From: Watkins, Robert
Sent: Wednesday, October 20, 2021 11:09 AM
To: Kevin Riddle
Cc: Werner, Jeffrey B
Subject: October 2021 BAR Decision

Certificate of Appropriateness

BAR 21-05-03

Project: Three-story apartment building with below-grade parking

PLANTINGS & PAVING

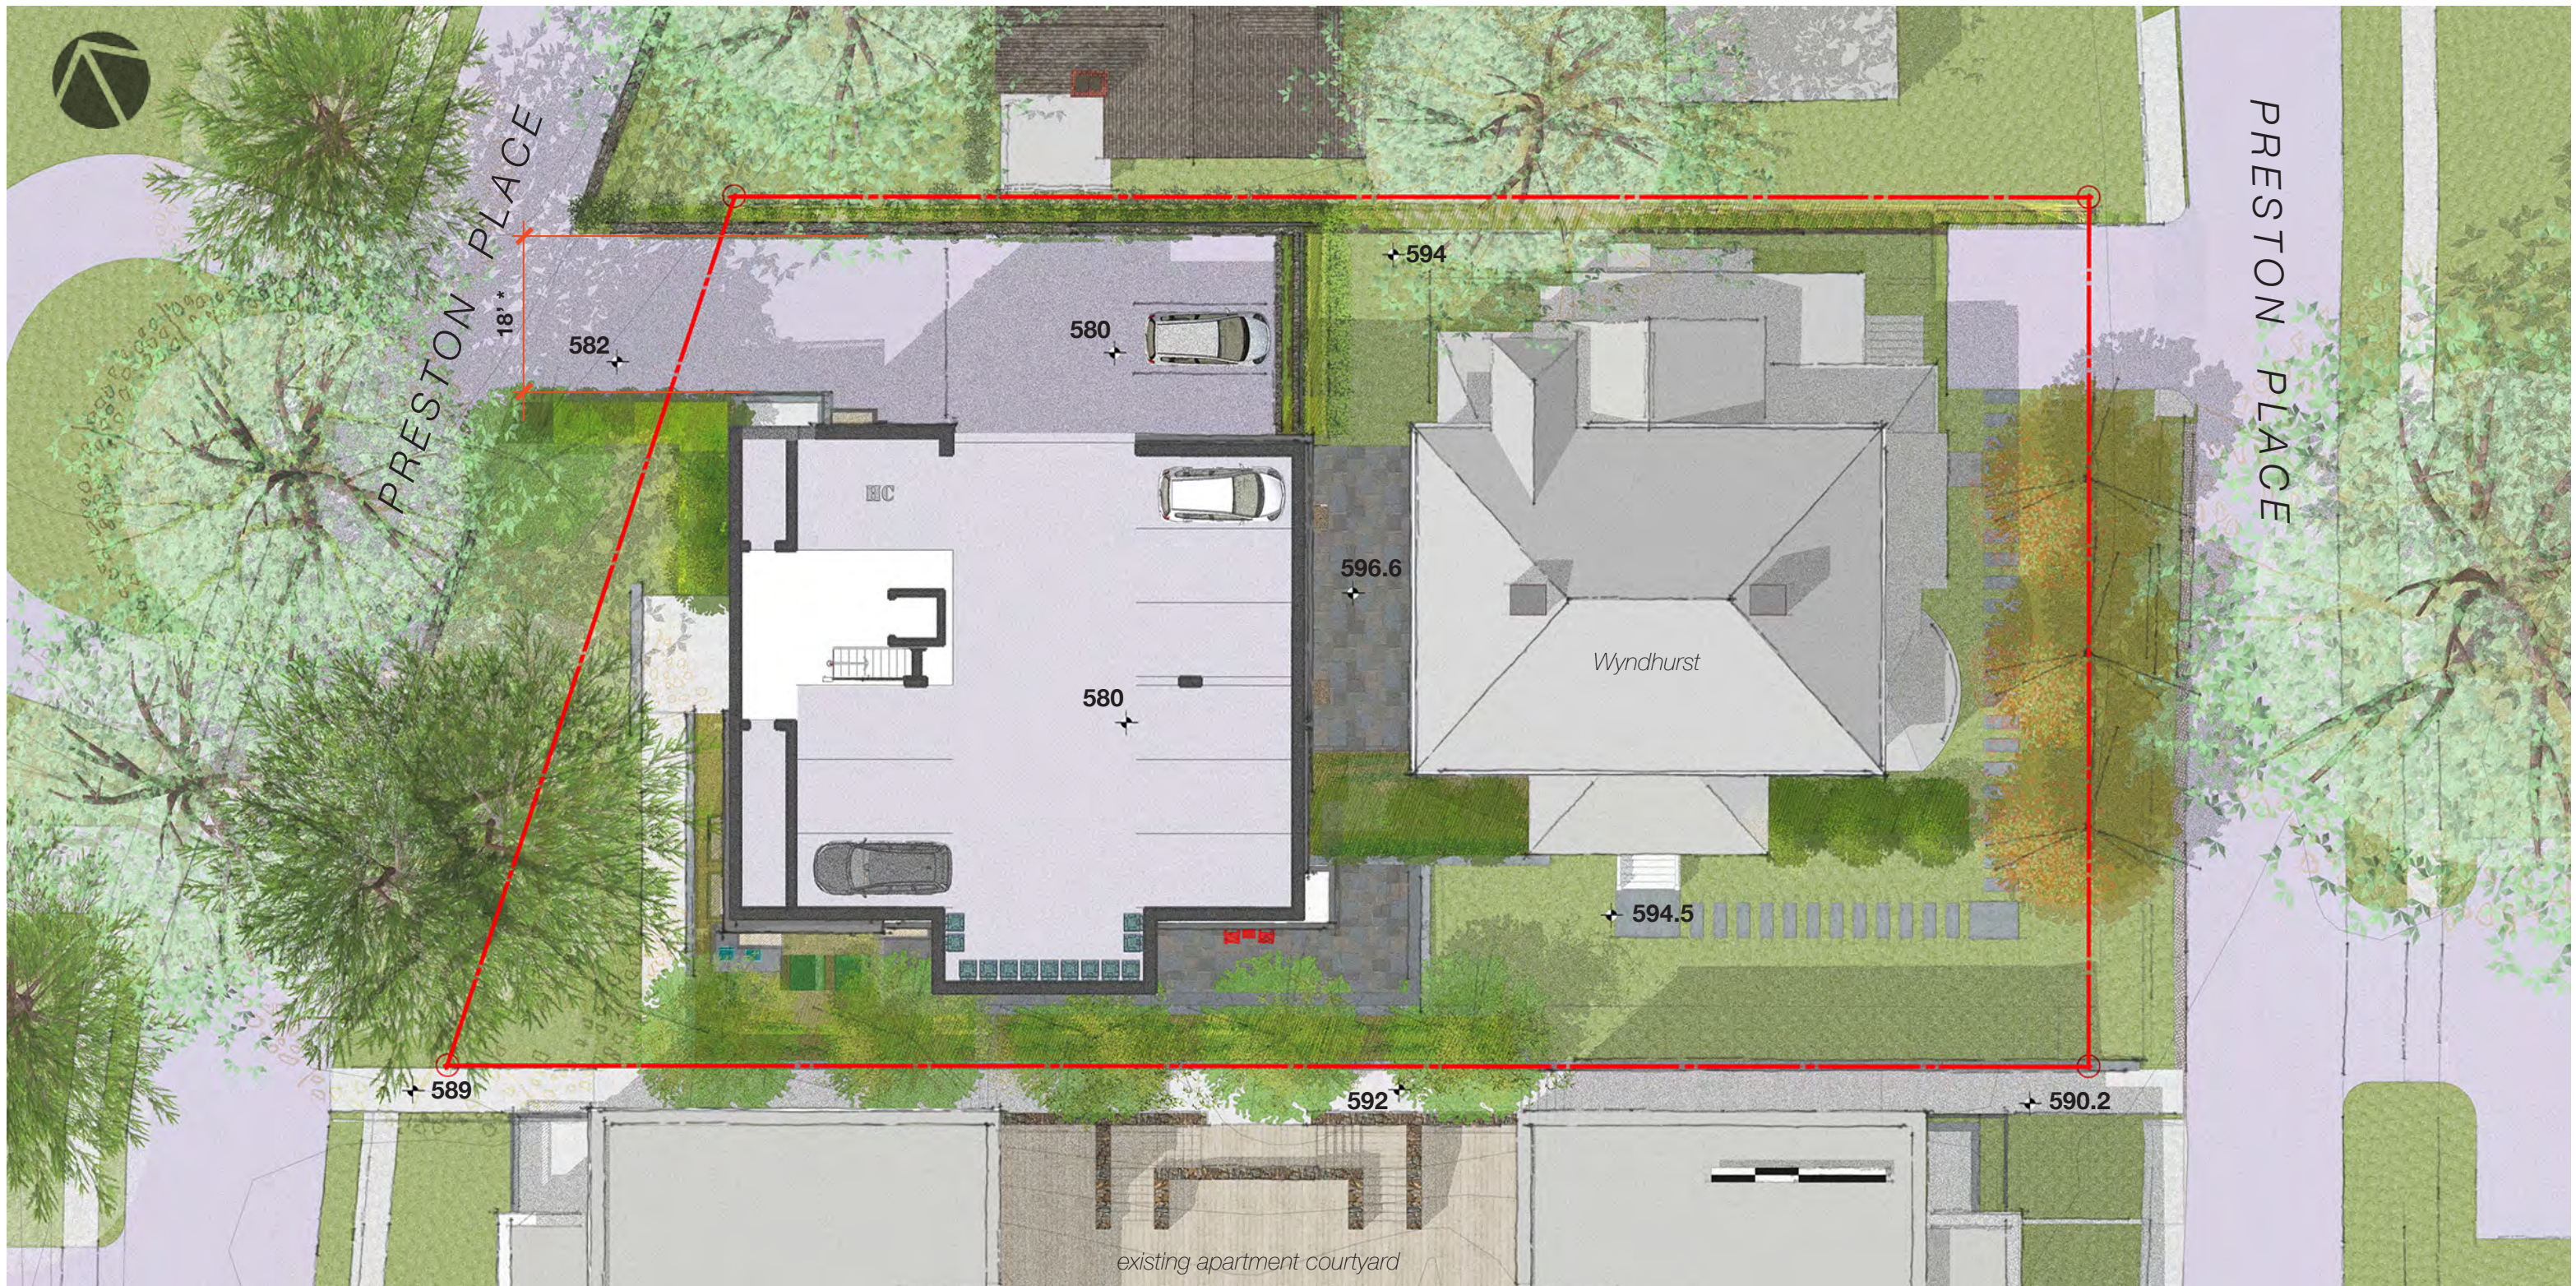
- *We make a recommendation to the city traffic engineer that the proposed driveway be 12' wide or as narrow as possible*
- *We recommend that a smaller statured tree or shrub be selected from the City's Master Tree List for the site of the currently proposed fringetrees in front of Wyndhurst*

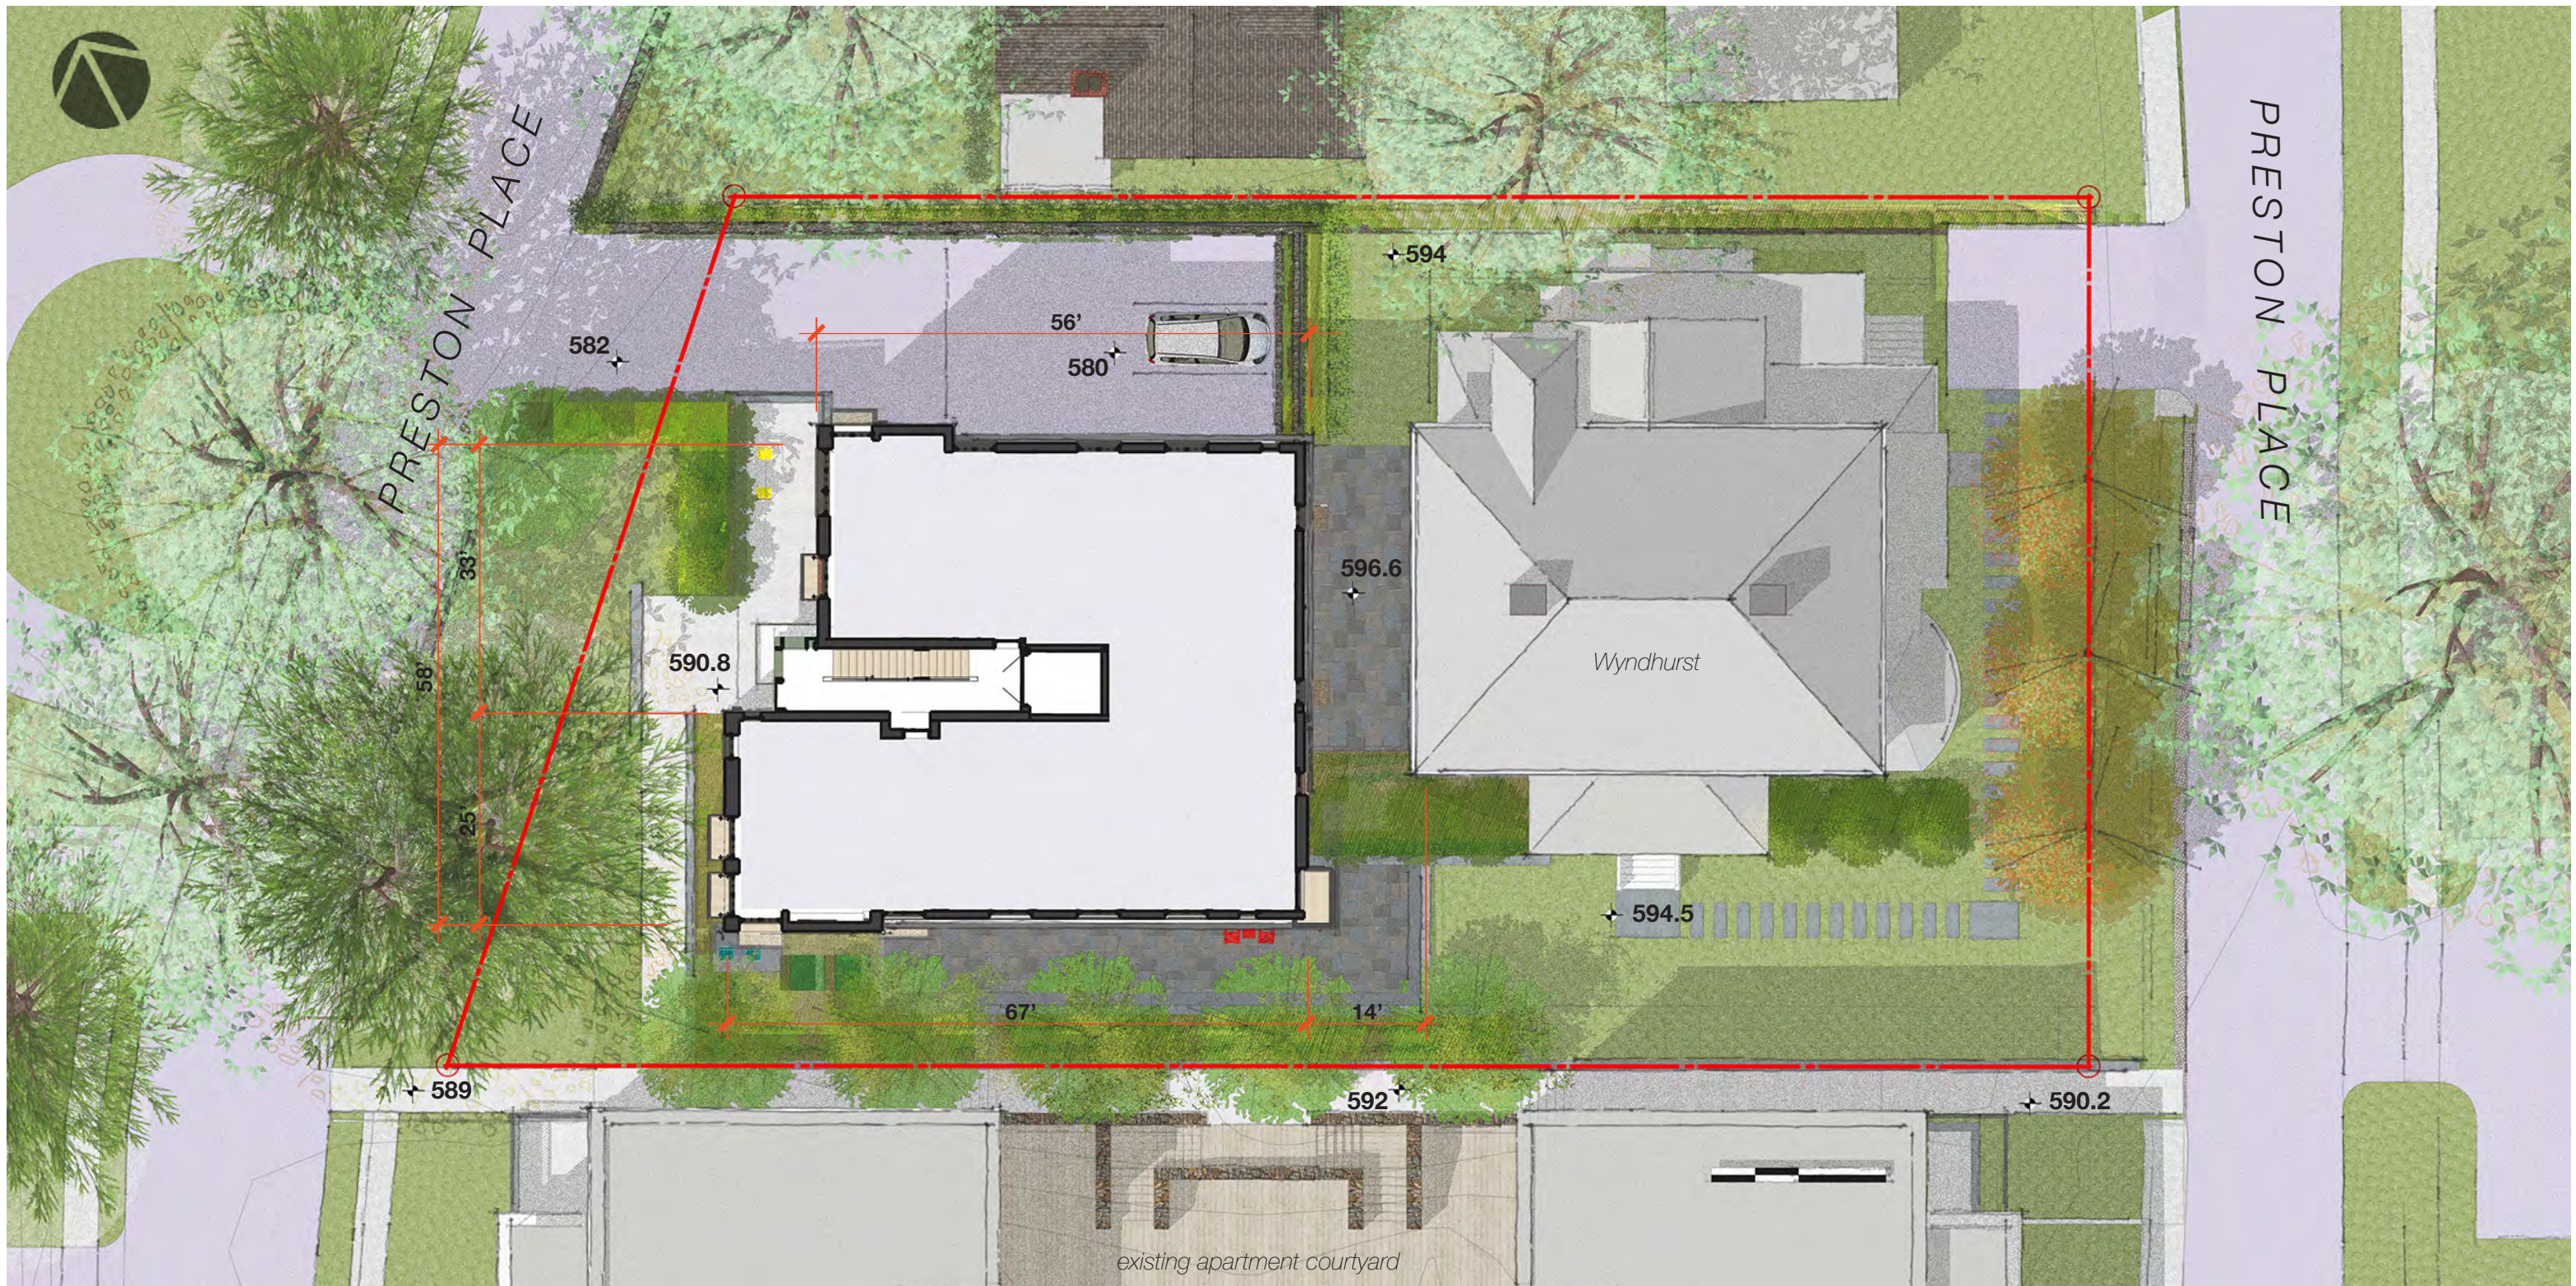
- Width of proposed driveway is narrower than required by Code. City Code Section 34-972(a)(5) allows for the BAR to make recommendations [to the city traffic engineer] regarding modifications in the required driveway entrance widths.

* Proposed width is narrower than ordinance allows-- pending zoning administrator's exception/approval

WDGE2 LED
Architectural Wall Sconce

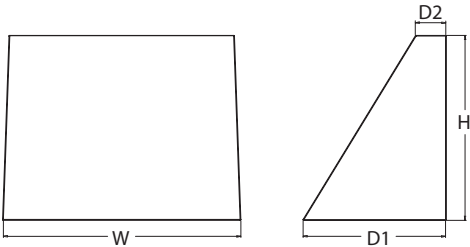
- *We require that all lighting be dimmable, if that option is available with the specified light fixtures, the Color Temperature not exceed 3,000K, and the Color Rendering Index is not less than 80, preferably not less than 90.*

- Proposed fixtures are *available* with lamping that is consistent with the BAR's established guidelines: Dimmable; Color Temperature not to exceed 3,000K; Color Rendering Index of not less than 80, preferably not less than 90. BAR should establish a condition that all lamping used will comply.
